**From:** Daniel Winter  
**Sent:** Tuesday, 27 July 2021 8:30 am  
**To:** Amy Bennetts  
**Subject:** RE: RM200488 RM200489 Gravel Extraction - NMP

- Planscapes AEE dated 15 June 2021
- Hegley acoustic report dated December 2019
- Hegley Noise Management Plan dated May 2021

Response Minute no 1 - Item 1 - Mr Winter - Noise

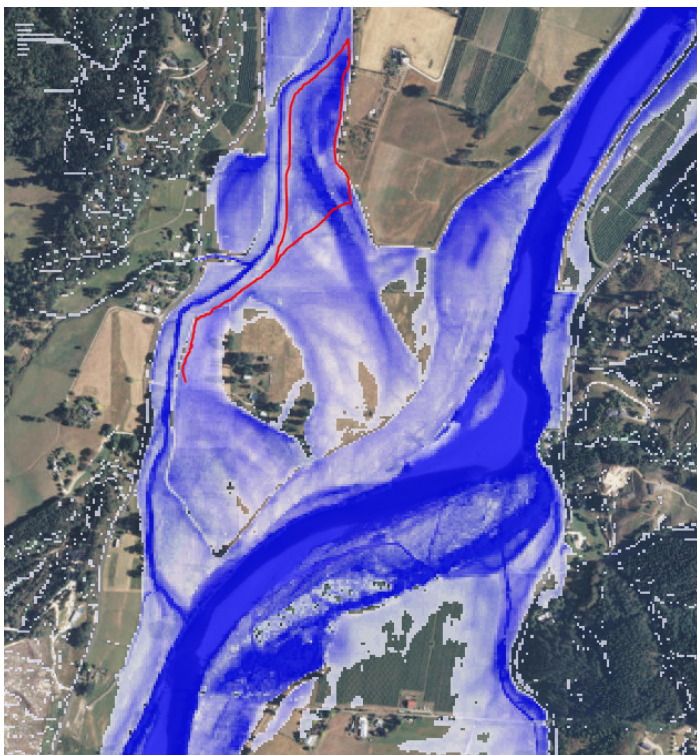
A shelterbelt type planting is proposed to go right across the west bank channel that accepts flood flows, and while there is already high levels of woody vegetation in this overflow channel in places, this would be right across and close to the head of this channel. The planting lines running parallel with river flow I am not concerned about as long as they don't plant too close to the stopbank (i.e. within 5m).

The red line below shows the proposed planting lines overlaid on a Q10 event (flows are bottom to top).

My preference would be for no plantings or fencing to cross the channel in this vicinity, while flexible 'laydown' plantings such as toe toe, Carex sp. or scattered single trunked trees (say no more than one per 10m) could be entertained, but then may not achieve the desired visual screening the applicant is seeking.
